STREET, STORMWATER, AND MASTER DRAINAGE PLAN

MANOR AT BAILEY FARMS, FIRST PLAT

RELEASED FOR CONSTRUCTION
As Noted on Plan Review

Development Services Department
Lee's Summit, Missouri
12/14/2023

SHEET
25

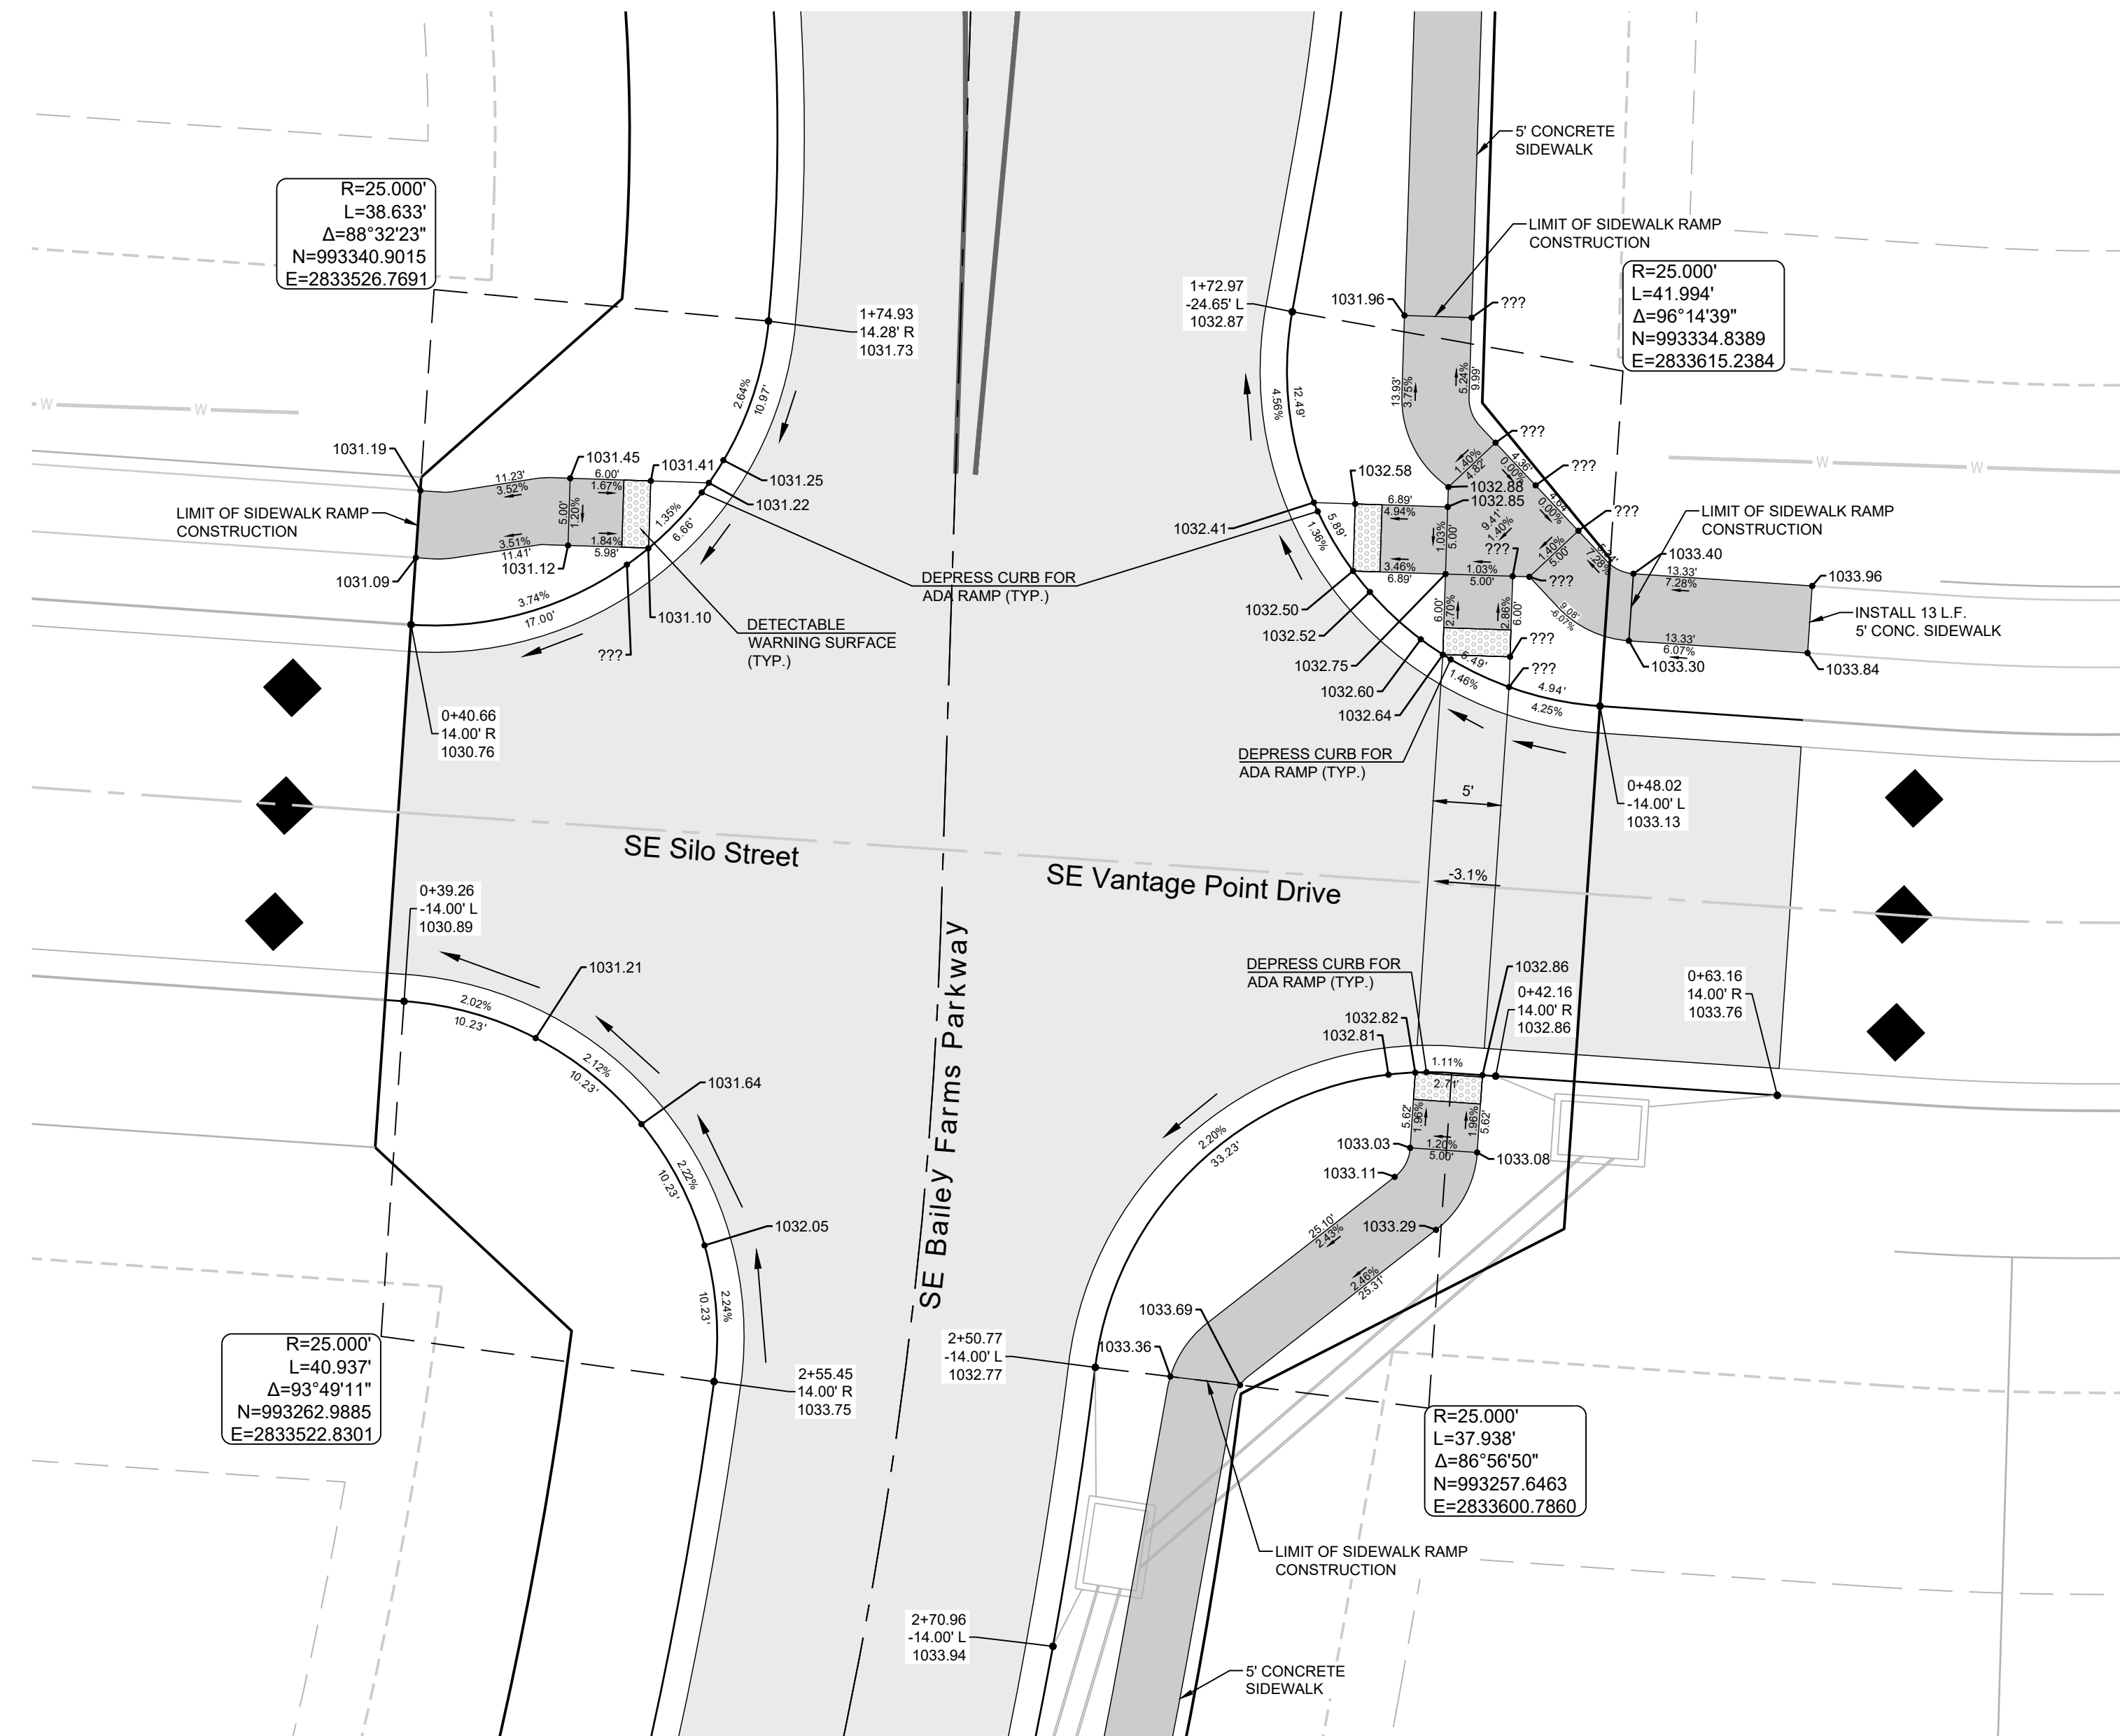
****NEED TO BE UPDATED PER NEW STREET PROFILE AND SECTION. NO LONGER CROWNED NORTH OF INTERSECTION. WILL NEED DRY CURB.**

STORM LAYOUT SHEET

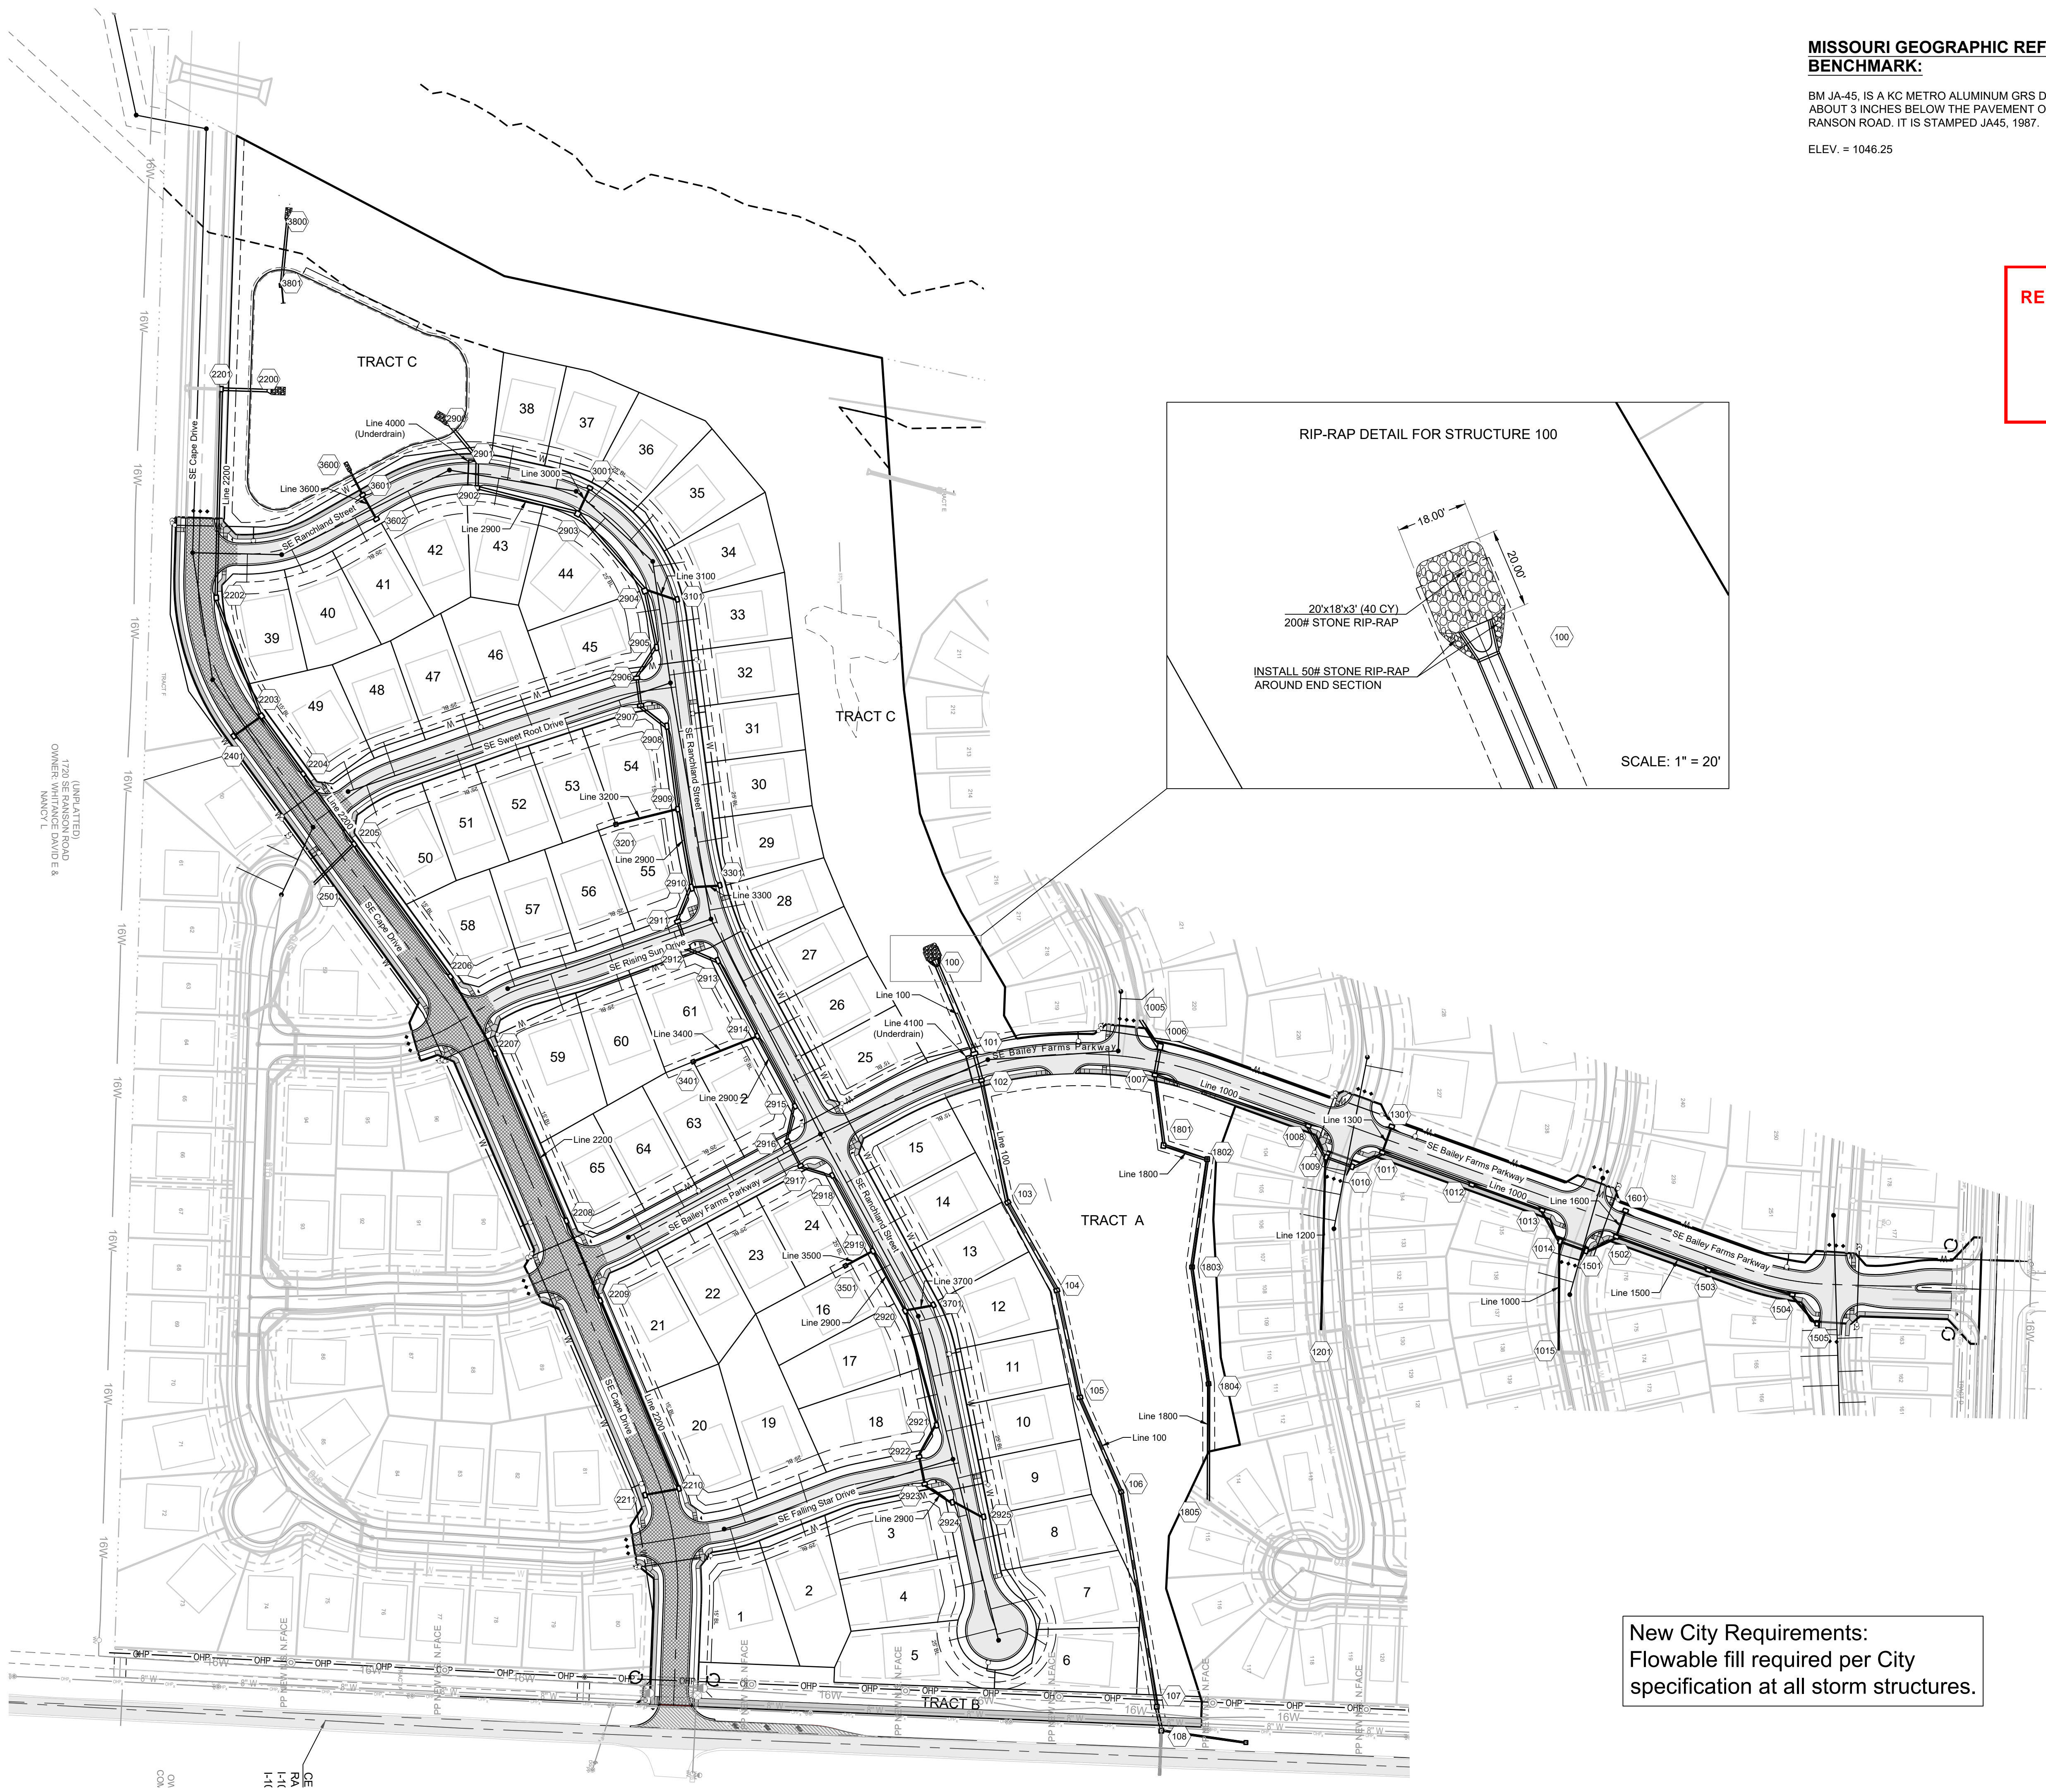
**New City Requirements:
 Flowable fill required per City
 specification at all storm structures.**
